North Hertfordshire District Council

Building Conservation comments

File Ref: 25/00253/FPH & 25/00254/LBC

Address: Cammocks, Chapel Street, Hinxworth, Hertfordshire SG7 5HN

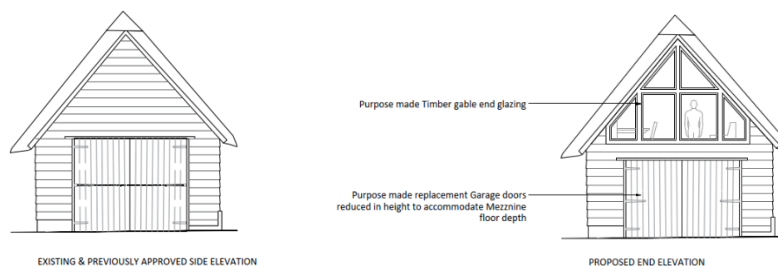
- 4.4 I met with the applicant on site at which I misinterpreted the plans as I thought the existing barn doors were to remain with the new internal first floor dropping down behind the doors effectively creating a bulkhead. This is not the case. The existing opening is to be modified to receive barn doors reduced in height so that the first floor can run through without impeding the opening.

- 4.5 The alternative would be to keep the existing opening/doors and to either create a bulkhead behind or alternatively, step up onto a raised platform where the sofa bed is positioned. The latter is my preferred option and one that I explored with the applicant. I would welcome the architect's thoughts on this.

- 4.6 If the applicant is willing to consider retaining the existing doors (this would minimise works to the building) then the apex glazing would be set slightly higher, thus would cover a slightly smaller area and would therefore have less impact on the listed building. The gable end framing and the existing doors are of no special interest so a modification either way could be made to the gable end without necessarily occasioning harm. However, considering the Google Maps image above there is merit in seeking to slightly reduce the amount of glazing.
